# REGIONAL REVIEW FINDING

ARC REVIEW CODE: R809291

**Submitting Local Government:** Cobb County  
**Name of Proposal:** Riverview

Preliminary Report:	September 29, 2008	<b>DEVELOPMENT OF REGIONAL IMPACT REVIEW REPORT</b>	Project:	Riverview # 1933
Final Report Due:	October 29, 2008		Comments Due By:	October 13, 2008

## DRI SITE PLAN (DRI ID: 1933)

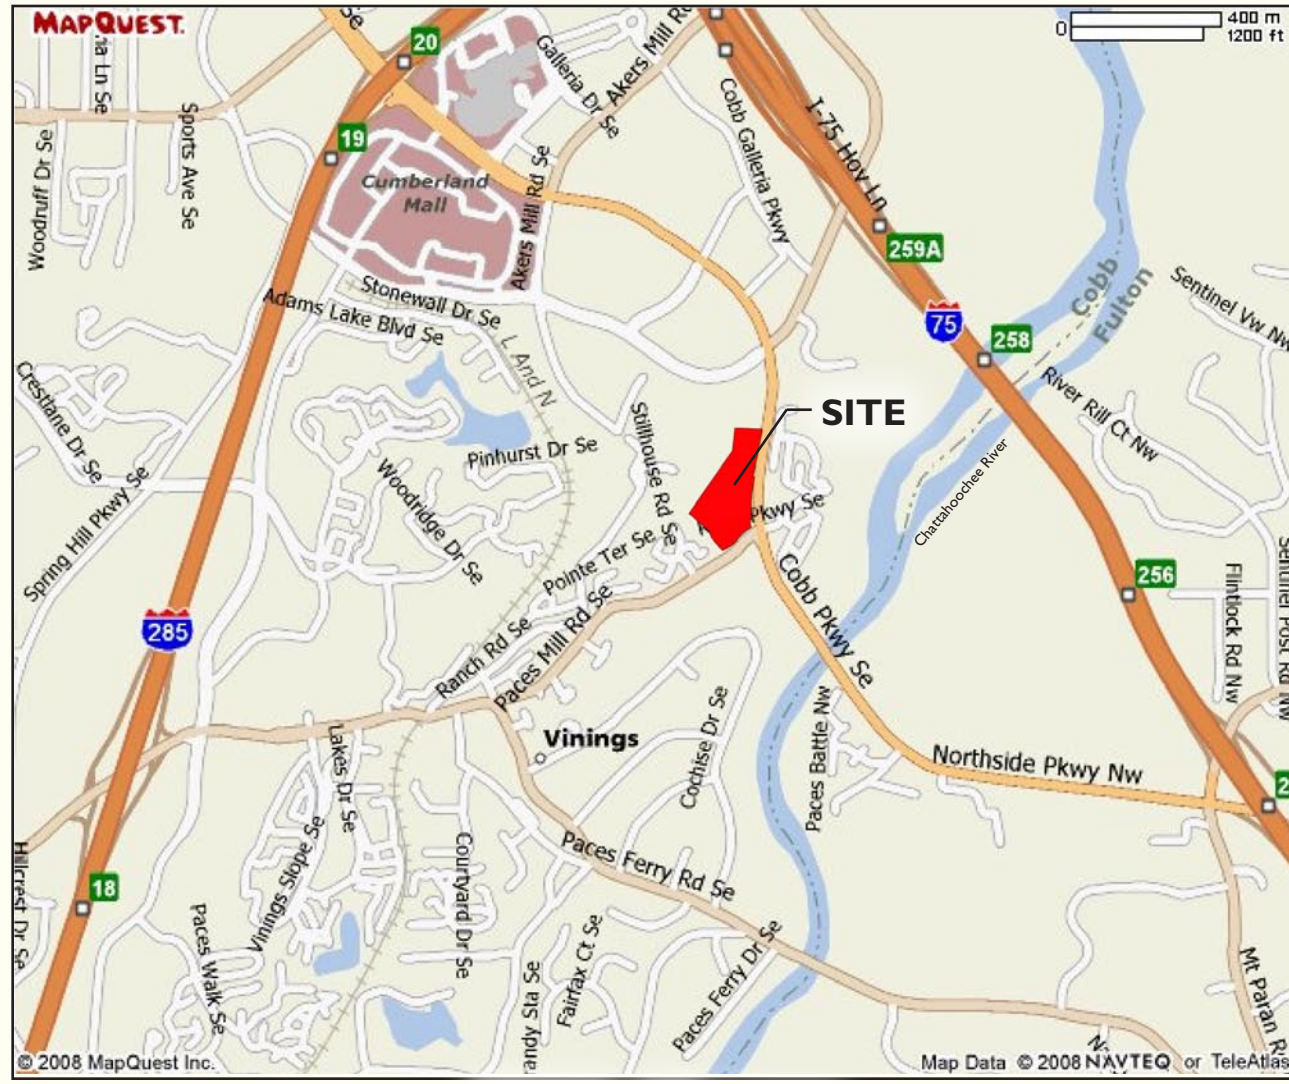
No streams are located on the project property, as shown on the regional USGS coverage and the original project plans. However, a stream does run adjacent to the property and the required Cobb County buffers are shown.

ARC has concerns with the proposed driveway on Paces Mill Rd closest to US 41. Its close proximity may cause traffic queues to interfere with the function of the intersection. ARC recommends closing that driveway to maintain the functionality of the mainline road capacity.
